APPLICATION FOR SOIL INVESTIGATION

SITE EVALUATION

SIR. NO. 21144
T.C. NO. PO 029-161-18
DATE: 6-27-84

RE: Property located at Mallard Creek Rd., Lot 21

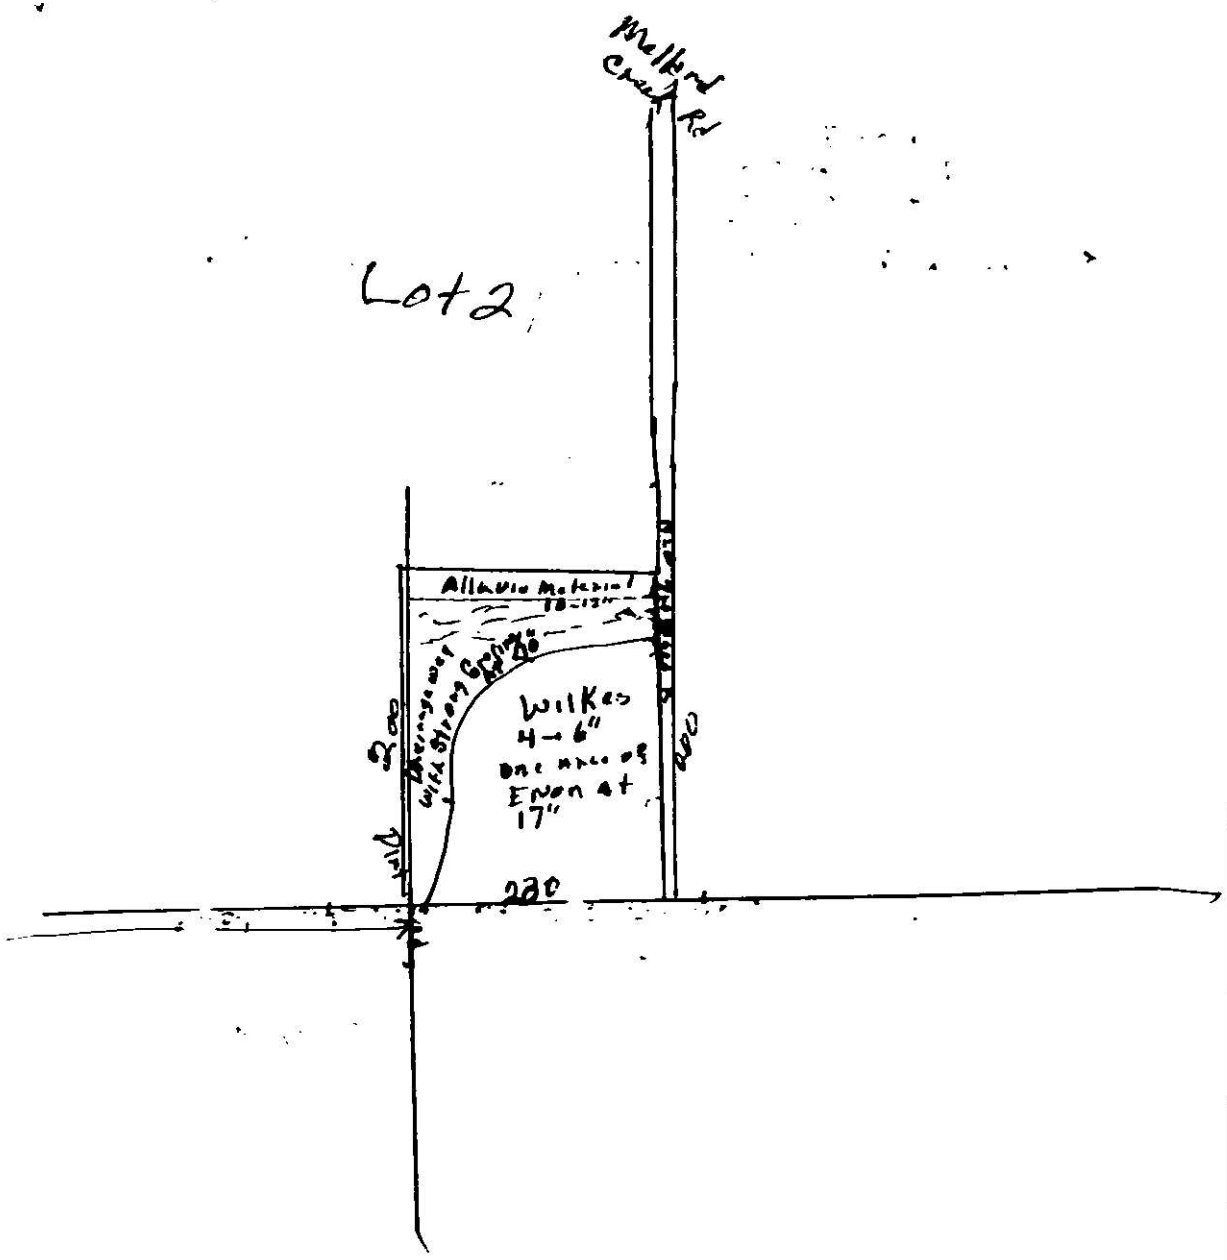
FACTORS	AREA 1	AREA 2	AREA 3	AREA 4
1. SLOPE (%)	S / (PS) 2-8 / U	S / (PS) 2-6 / U	S / PS / U	S / PS / U
2. SOIL TEXTURE (12-36 inches) Sandy, Loamy, Clayey (Note 2-1 Clay)	S / PS mixed clay / (U)	S / PS mixed clay / (U)	S / PS / U	S / PS / U
3. SOIL STRUCTURE (12-36 inches)	S / PS weak blocky / (U)	S / PS weak blocky / (U)	S / PS / U	S / PS / U
4. SOIL DEPTH (inches)	S / [illegible] 4-17 / (U)	S / PS. 10-20 / (U)	S / PS / U	S / PS / U
5. RESTRICTIVE HORIZONS (Inches) (Impervious strata, Rock)	S / PS none / U	S / (PS) none / U	S / PS / U	S / PS / U
6. SOIL DRAINAGE/GROUNDWATER (external and internal)	S / PS water table less 10" / (U)	S / PS water table 5-10" / (U)	S / PS / U	S / PS / U
7. OTHER (Specify)	S / PS / U	S / PS / U	S / PS / U	S / PS / U
8. SOIL GROUP	IVe	IVe		
9. SITE CLASSIFICATION	Unsuitable	Unsuitable		
10. SOIL SERIES	ENON Wilkes	Drainage Way

Lot 2
Alluvio Material
Wilkes
4 → 6"
Enon at
17"
200
200
230

At your request, a field investigation was conducted on the property designated above and was classified unsuitable for the installation of a ground absorption sewage disposal system. A copy of the site evaluation report is enclosed for your information.

Sites classified as unsuitable may be utilized for soil absorption disposal systems provided engineering, hydrogeologic, soil and environmental studies indicate that a suitable septic tank system or a suitable alternate system can be reasonably expected to function satisfactorily.

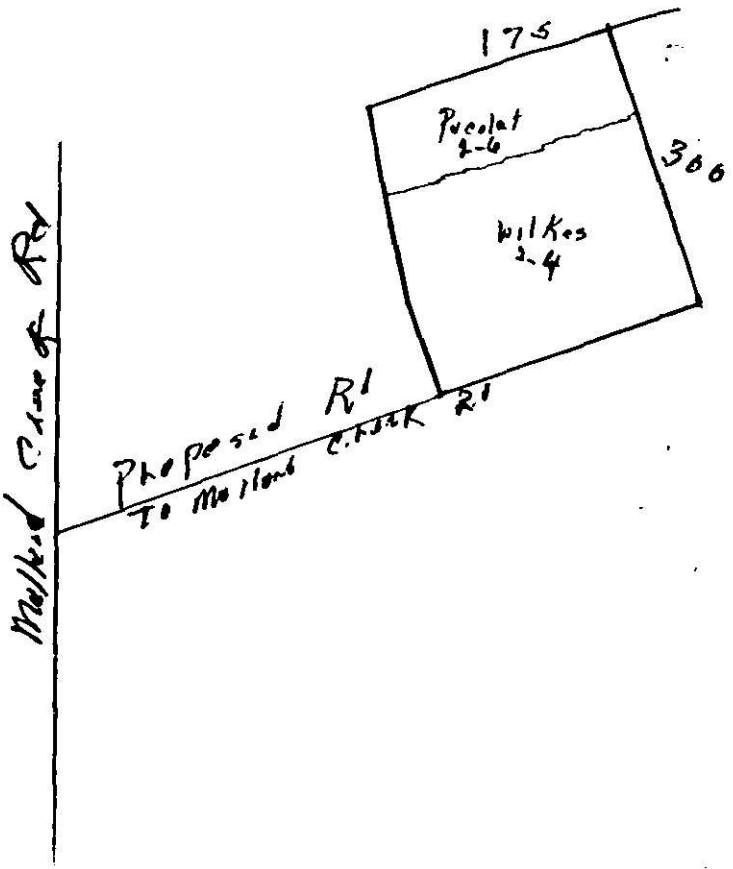
FACTORS	AREA 1	AREA 2	AREA 3	AREA 4
1. SLOPE (%)	S (PS) U 2-4	S (PS) U 2-6	S PS U	S PS U
2. SOIL TEXTURE (12-36 inches) Sandy, Loamy, Clayey (Note 2-1 Clay)	S PS (U) Mixed Clay	S (PS) U Clayey	S PS U	S PS U
3. SOIL STRUCTURE (12-36 inches)	S Weak PS Blocky (U)	S (PS) Blocky U	S PS U	S PS U
4. SOIL DEPTH (inches)	S PS (U) 6-18"	S PS (U) 12-16"	S PS U	S PS U
5. RESTRICTIVE HORIZONS (Inches) (Impervious strata, Rock)	S PS None (U)	S (PS) None U	S PS U	S PS U
6. SOIL DRAINAGE/GROUNDWATER (external and internal)	S PS Slow (U)	S (PS) Adequate U	S PS U	S PS U
7. OTHER (Specify)	S PS U	S PS U	S PS U	S PS U
8. SOIL GROUP	IVb	IVe		
9. SITE CLASSIFICATION	Unsuitable	Unsuitable		
10. SOIL SERIES	Wilkes	Pacolet

175
Pocolat
2-6
366
Wilkes
2-4
Proposed R1
To Mollard Creek R1
Mollard Creek Rd

At your request, a field investigation was conducted on the property designated above and was classified unsuitable for the installation of a ground absorption sewage disposal system. A copy of the site evaluation report is enclosed for your information.

Sites classified as unsuitable may be utilized for soil absorption disposal systems provided engineering, hydrogeologic, soil and environmental studies indicate that a suitable septic tank system or a suitable alternate system can be reasonably expected to function satisfactorily.
